Expert Report on Air Quality, Contaminants of Concern, and Human Health Risk Assessment for the Stibnite Gold Project FEIS and draft Record of Decision

From: Ian von Lindern, P.E., PhD
Co-Founder, TerraGraphics International Foundation
1075 Snow Road, Moscow, Idaho 83843
(208) 596-8577
Email: ian@terrafound.org

Pursuant to 36 CFR Part 218, I am filing this Objection to the FEIS and Draft ROD for the Stibnite Gold Project (“Mine” or “Project”) issued by Payette National Forest Supervisor Matthew Davis on September 6, 2024. See <https://www.fs.usda.gov/project/?project=50516>.

Figure 2. Cumulative Risk (CR) and Margin of Safety (MOS) using the Project-specific (6/70) Adjustment Factor for a 6-year project

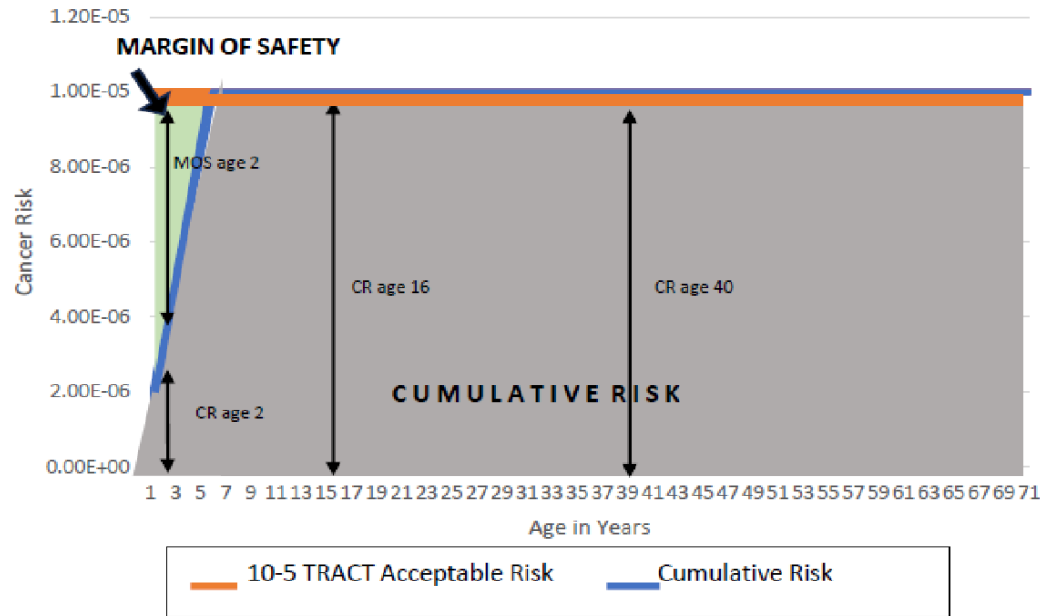
<p>DEQ's assertion that the SGP Project-specific Adjustment Factor is health protective implies that it is permissible to subject these sensitive sub-populations to equivalent >10-4 risk levels from conceptus to school age because it will average out over the remainder of the child's life.</p> <p>The SGP Project-specific 16/70 adjustment factor is a classic example of dose-averaging. The practice of averaging cancer risk over a receptor's lifetime was progressively developed as an issue in the risk analyses applied to contaminated hazardous waste sites during the 1990's and early 2000's. The USEPA comprehensively considered the application of dose-averaging or risk amortization in the Science Advisory Board (SAB) review <i>Supplemental Guidance for Assessing Susceptibility from Early-Life Exposure to Carcinogens</i>. (USEPA 2005a).</p> <p>The excessive risk associated with early life-stage carcinogenic dose accumulation has long been recognized by most health authorities and specific protections were incorporated in USEPA RAGS policy in 2005. The USEPA recommends a quantitative adjustment of the toxicity value to account for early life susceptibility. This guidance recommends a 10-fold adjustment for exposures during the first 2 years of life; and a 3-fold adjustment for exposures from ages 2 to <16 years of age for carcinogens exhibiting mutagenic mode of action (MOA). (EPA 2009).</p> <p>As another example, consider the case of two additional 6-year projects being implemented near the source represented in Figure 2 at years 9 and 18 in this child's life. Figure 4 shows that the child - already exposed to the</p>

full lifetime allowable cancer 1×10^{-5} risk by age 6 - will have double (2×10^{-5}) the acceptable risk level by adolescence, and will carry the three times the allowable lifetime cumulative risk burden (3×10^{-5}) through the reproductive stage of life.

Figure 4. Cumulative Risk using the Project-specific (6/70) Adjustment Factors for 3 Successive 6-year Projects

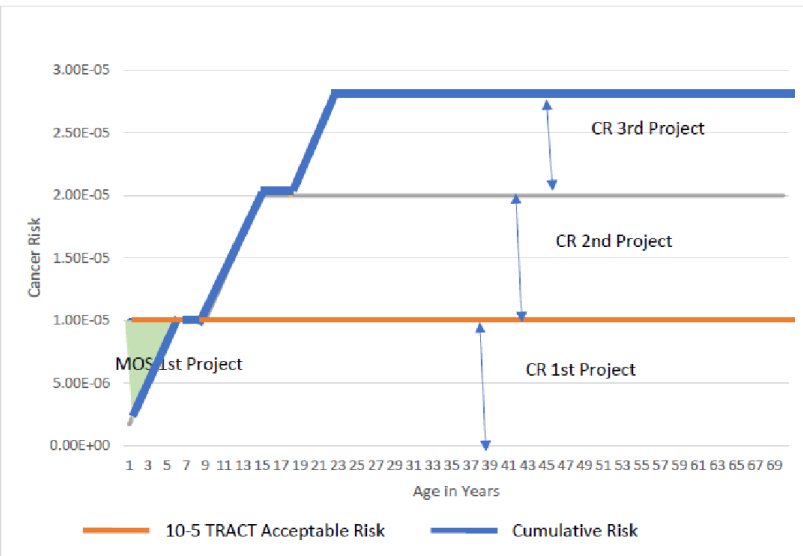
Under Section 586 DEQ must consider these new projects incrementally. DEQ would be prohibited from talking into account cumulative lifetime exposures associated with the earlier projects in a new source PTC application and would be required to approve the projects.

At the SGP, for example, should Perpetua apply to open another pit at the mine, DEQ would be required to ignore the cumulative lifetime risk and cancer burden imposed by the proposed SGP 16-year LOM scenario.

Figure 5a. Cumulative Risk (CR) and Margin of Safety (MOS) under Proper Implementation of Idaho TAPS Rules for 3 Successive 6-year Projects

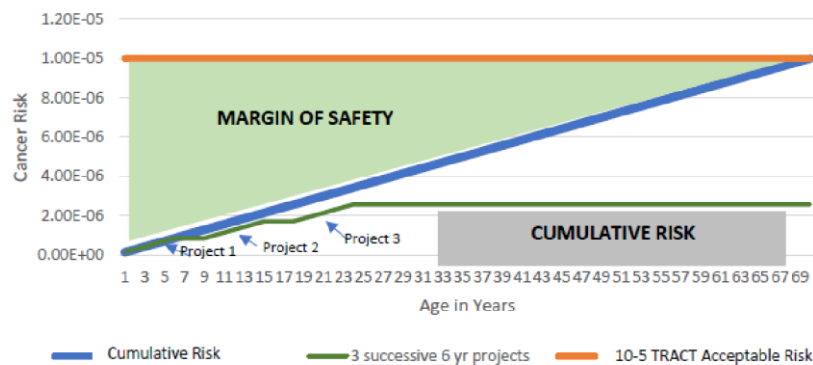
Figures 5a and 5b demonstrate the same three sequential project scenarios under the proper implementation of the current TAPS rules using the maximum one-year annual average ambient air carcinogen concentration that incorporates the MOS to accommodate additional sources. Figure 5a shows the cumulative risk from all three projects. In this case a child growing up in the community would be protected from excess cancer risk through all life stages even though DEQ would not consider the earlier exposure in applying Section 586. The lifetime risk accrued by the individual is 2.6×10^{-6} as opposed to 3.0×10^{-5} in the earlier example.

Allowing use of the SGP Project Specific adjustment factor, as the FS advocates, would increase lifetime cancer risk by 12 times in this example.

Figure 6. Effect of DEQs Application of the Project-specific Adjustment Factors Compared to Required TAPS Calculation

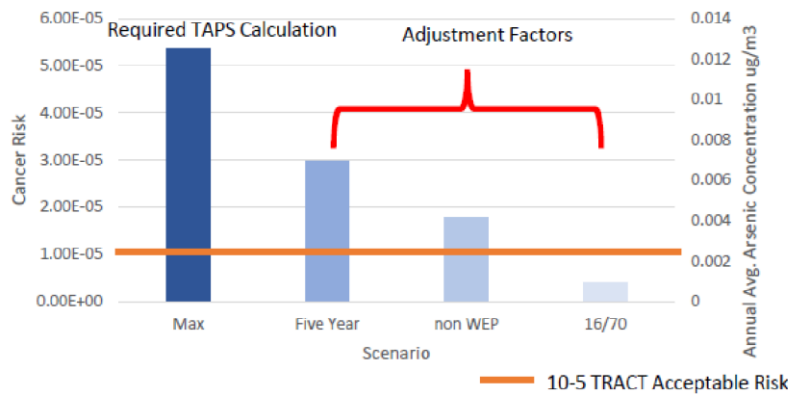
These results are shown in Figure 6. DEQs sequential application of the three SGP Project-specific Adjustment Factors underpredicts cancer risk by 13 times.

OBJECTION: The above analyses and discussion show the use of dose-averaging underestimates cancer risk by 13 times for the proposed 2021 MMP. The Board of DEQ has determined this methodology is inappropriate and increases cancer risk. The FS was aware of these conclusions when the ROD was issued, but nevertheless continues to endorse FS cancer risk estimates which are more than order of magnitude less than those indicated in the DEQ Board testimony. This assertion that the SGP will meet cancer risk criteria, that even Perpetua’s own analyses refute, is sufficient cause to withdraw the DROD.
